# ASSESSMENT REPORT

## IMAX DARLING HARBOUR SSD 7388 MOD 3

**Figure 8:** Proposed view towards the northern podium elevation beneath the Western Distributor (Source: modification application)

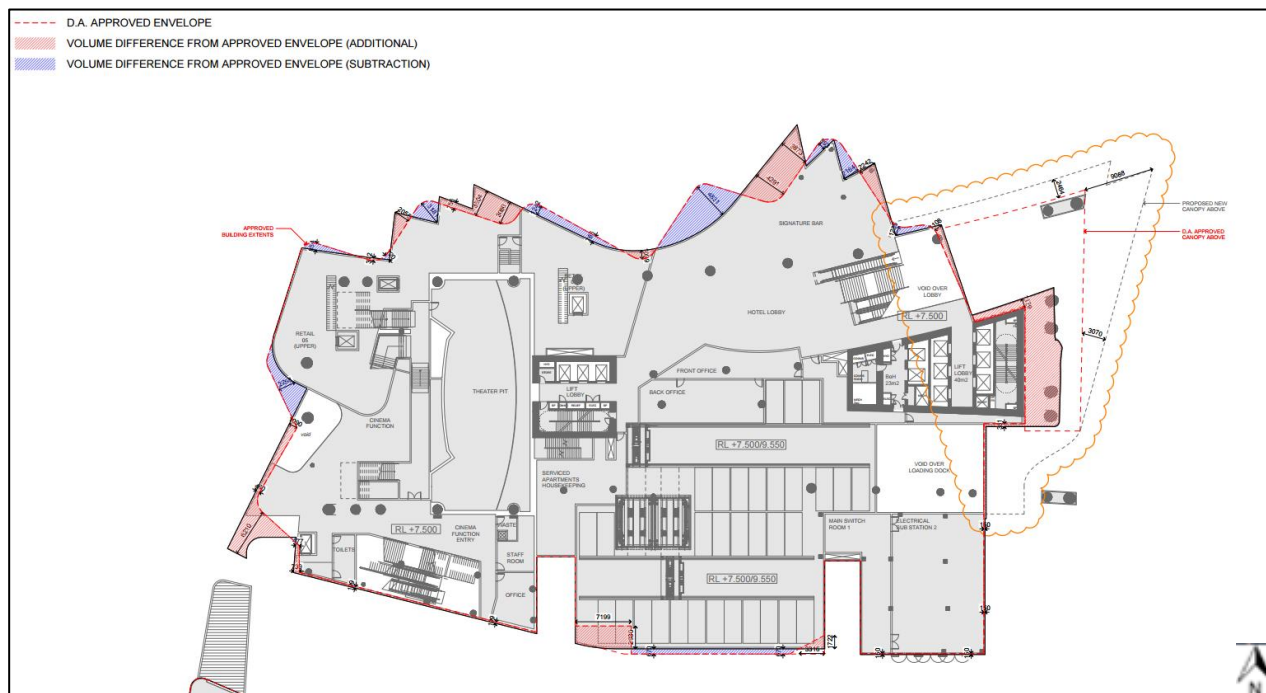
The modification seeks approval to increase and decrease the layout and shape of the podium and includes the following key amendments (**Figures 5 to 9**):

- amend the shape of the northern elevation of the podium from an undulating curved form
- expand the eastern portion of the podium by up to 1.18 m
- expand the western portion of the podium by up to 4.75 m
- increase the height of the podium above the car-stacker and electrical substation by up to 2.35 m
- incorporation of an awning on the north-eastern side of podium
- other minor increases and decreases to the width and height of the podium.

The Department considers the proposed changes to be minor in the context of the overall development and acceptable, as:

- the amendment of the northern elevation from an undulating curved shape would continue to provide an aesthetically pleasing architectural treatment and would also integrate appropriately with the overall shape of the tower component of the development.
- the increases and decreases in podium height would be largely screened by the Western Distributor, and are unlikely to be noticeable
- the proposed amendments to the tower component are minor in nature and would not have a noticeable impact on the overall design or appearance of the building
- the amendments would not adversely interrupt pedestrian sight-lines around the north-east and north-west corners of the podium
- the updated Accessibility Statement submitted with the application confirms the modified podium would continue to be accessible.

The Department therefore concludes the amendments to the podium are minor in nature and would not result in any adverse impacts. The Department recommends condition B26 is modified to refer to the updated Accessibility Statement.

**Figure 9:** Proposed bicycle parking locations within the public domain (Source: Modification application)

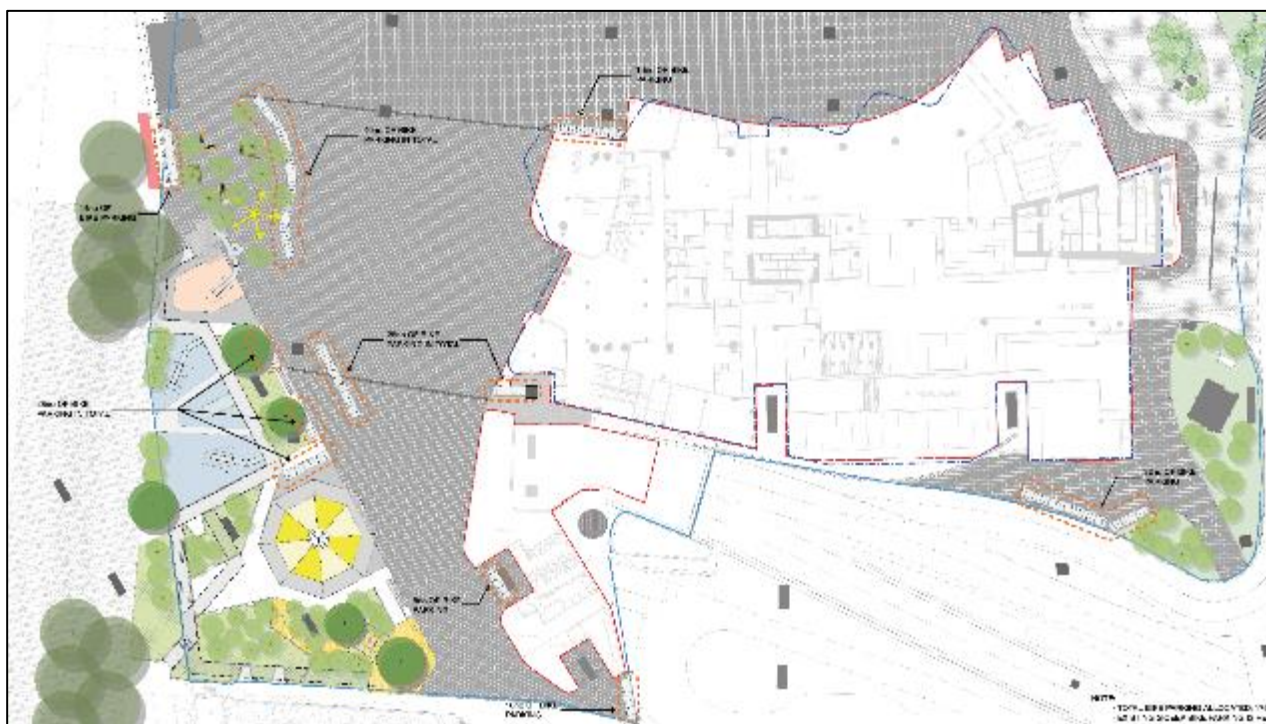
- the application should demonstrate how the modification maintains design excellence
- bicycle parking within the public domain should not create barriers or impede pedestrian movement and be located in accordance with Crime Prevention Through Environmental Design (CPTED) principles
- consideration should be given to enhancing sightlines through the public domain.

- the total number of bicycle parking spaces should not be reduced
- the Management and Operation Plan for the car stacker, loading dock, valet service and porte-cochere should be updated.

One public submission was received on the proposal, which objected to the provision of bicycle parking within the public domain.

<b>Issue</b>	<b>Consideration</b>	<b>Recommendation</b>
<i>Bicycle parking</i>	<ul style="list-style-type: none"> <li>• The proposal includes the following amendments to bicycle parking: <ul style="list-style-type: none"> <li>◦ reduction of 31 bicycle parking spaces (from 239 to 208 spaces) comprising 176 visitor and 32 staff spaces</li> <li>◦ relocation of 176 visitor bicycle parking spaces from within the building to the surrounding public domain</li> <li>◦ reconfiguration of end of trip facilities</li> </ul> </li> <li>• The Department notes the reduction of 31 bicycle parking spaces, and associated changes to end of trip facilities, would comply with the Sydney Development Control Plan 2012 and therefore considers the changes are acceptable.</li> <li>• Concern was raised in the public submission about bicycle parking reducing the usability of the public domain.</li> <li>• The Department considers the proposed relocation of visitor bicycle parking to the public domain is acceptable in this instance as: <ul style="list-style-type: none"> <li>◦ the bicycle stands are proposed in locations that would not obstruct pedestrian movement (refer to <b>Figure 9</b>) and are not situated in locations previously intended as green spaces</li> <li>◦ they would be more readily accessible for customers of the development and the broader Darling Harbour and Sydney International Convention, Exhibition and Entertainment Precincts</li> <li>◦ increased visibility of the bicycle parking is likely to promote cycling within the area</li> <li>◦ Council raised no objection.</li> </ul> </li> <li>• On this basis, the proposed amendments to bicycle parking are acceptable and would not have an adverse impact on the public domain. The Department recommends condition B10 be updated to take account of the above changes.</li> </ul>	The Department has recommended condition B10 be modified to take account of the changes to bicycle parking.

**Figure 10:** The approved variable footpath width plan (left) and the modified footpath width (right) (Source: SSD 7388 and modification application)

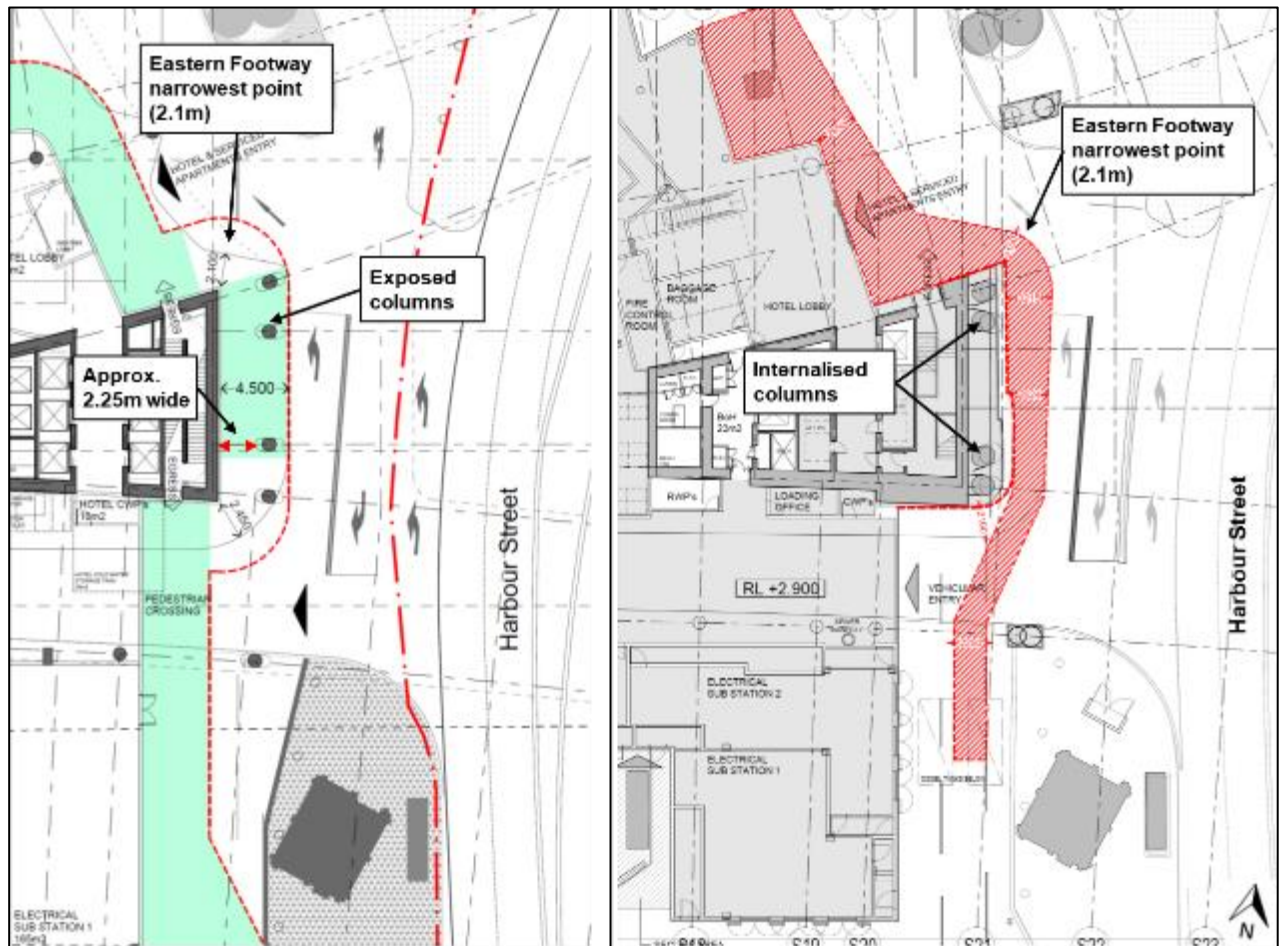
The modification proposes to amend the approved width of the north-south footpath located along the eastern boundary of the site, adjacent to Harbour Street, from 4.5 m (required by Condition B3) to a minimum of 2.1 m. The modification includes the expansion of the podium eastward and the internalisation of previously exposed structural support columns within the building. This amendment results in the relocation of the eastern footpath to the outside eastern edge of the podium, which alters the route and the width of the footpath. A comparison between the approved variable footpath width plan and the modified footpath is provided at **Figure 10**.

- the two-way pedestrian volumes along the eastern footpath peak at:
  - 2.25 pedestrians per minute during the PM peak hour
  - 0.9 pedestrians per minute during the PM peak hour
- the modified eastern footpath is capable of accommodating approximately 45 pedestrian movements per minute at its narrowest point (**Figure 10**).

The Department considers the revised footpath width is acceptable as:

- the TPIA confirms the modified footpath would continue to be capable of accommodating peak pedestrian movements
- the modified footpath would not be any narrower than the narrowest segment of the approved footpath (2.1 m)
- the eastern footpath is not a primary pedestrian route and due to its location and the constraints of surrounding road infrastructure it is unlikely to be a highly desirable route
- the removal of the structural columns from the footpath removes visual obstructions, and potential areas of concealment, which improves pedestrian sightlines and safety

The Department also notes the approved podium includes exposed structural columns located within the footpath. This would prevent the functional use of the full 4.5 m width of the footpath, effectively reducing its width to approximately 2.25 m.

The Department therefore considers the proposed revised footpath width is acceptable and recommends condition B3(a) be deleted.
